PSP 1059. Beveridge North West Precinct Structure Plan

Part B Submission

July 2020

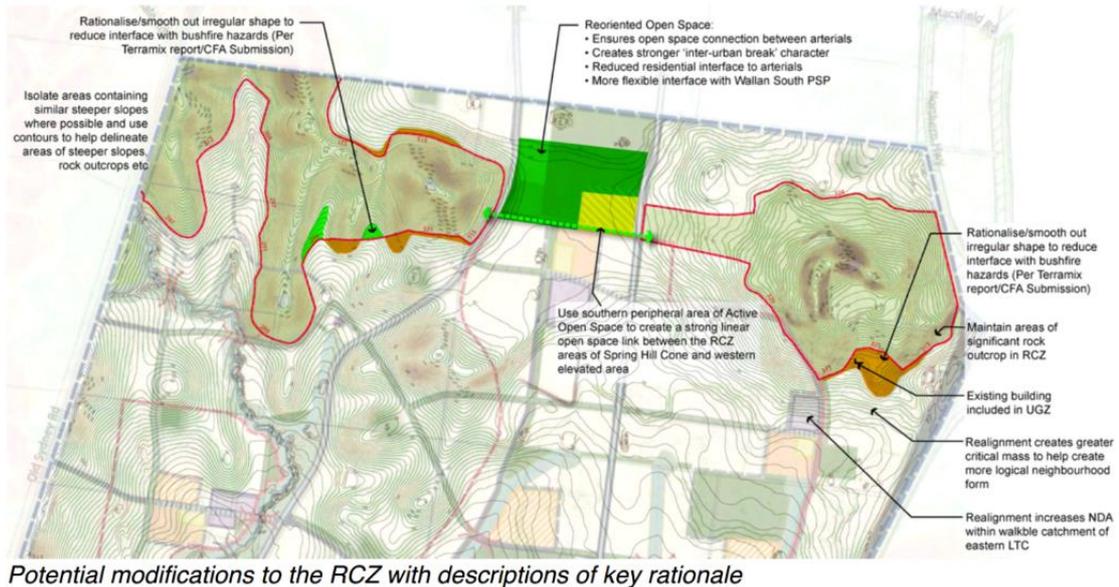
Combined, into map format, Mr Hanson recommends the following refinements to the RCZ boundary.

In the VPA's submission, these revisions strike an appropriate balance between protection of the landscape features and facilitating urban development. The revised boundary provides an appropriate response to bushfire risk by providing a more readily defensible edge, and reorients SR-01 to provide an open space connection between the two arterials (and the western hills and Spring Hill) while allowing the UGZ to be applied to areas with low landscape values.
